CONSTRUCTION VALUE ENGINEERING CHANGE PROPOSAL  
MISSOURI DEPARTMENT OF TRANSPORTATION

VECP 09-13

VE CONCEPT  
STAGING MODIFICATION

EB I-44  
Bridge L08654

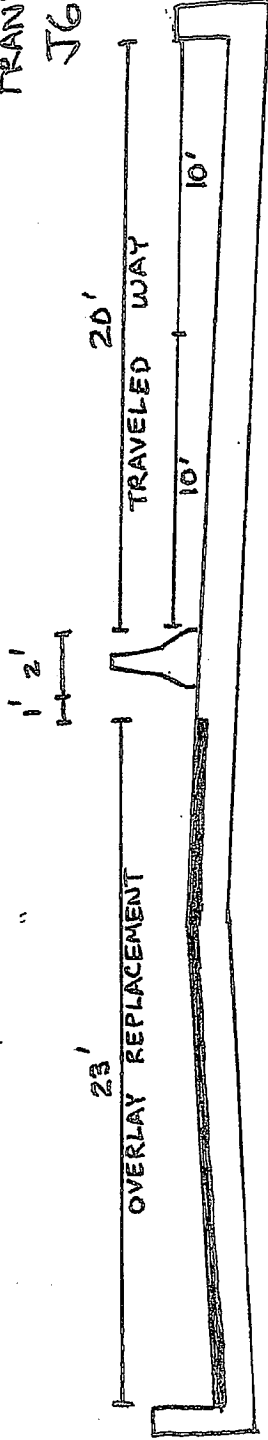
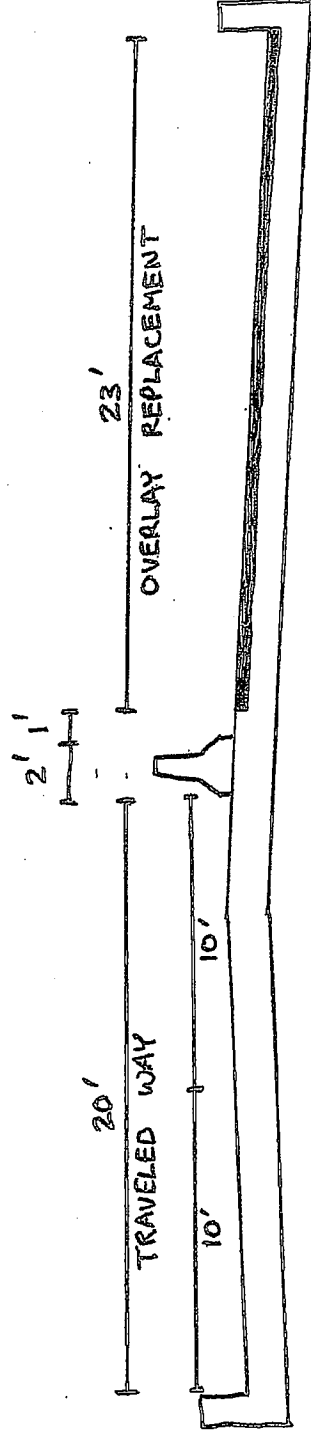
The original design on the above referenced project calls for a three staged replacement of the wearing surface of the eastbound bridge on I-44. The bridge is 46 feet wide which makes it possible to construct the wearing surface replacement in two stages, each with a 23-foot work area and 20-foot travel way. This results in a nearly 1/3 reduction in the temporary striping and temporary traffic barrier, and a reduced cost in the wearing surface removal and silica fume overlay.

Job special provision K allows 100 calendar days of work to be performed on eastbound I-44. Reducing the work to two stages reduces the number of days needed for curing concrete. In addition, more efficient work in wearing surface removal and silica fume overlay will allow the work on eastbound I-44 to be completed in 75 calendar days. This will reduce the impact this project has on I-44 traffic. Acceptance of this proposal will modify job special provision K such that liquidated damages will begin after 75 calendar days on eastbound I-44.

- Is the existing outside shoulder capable of handling the staged traffic

- Has anyone checked to see if the existing structure is capable of handling traffic

- Yes we will maintain 10' lanes
- James Kelley and Tim Schroeder will do the design and Sealing

information that was taken in 2006. Phil was confident that the existing shoulders would perform adequately if we kept the heavy vehicles (trucks) off the shoulder and we would limit the exposure to 1/2 of the 75 Day completion time.

- Consulted with Ray Jansen (MoDOT Bridge). Ray has no concerns related to traffic utilizing the outside shoulder.
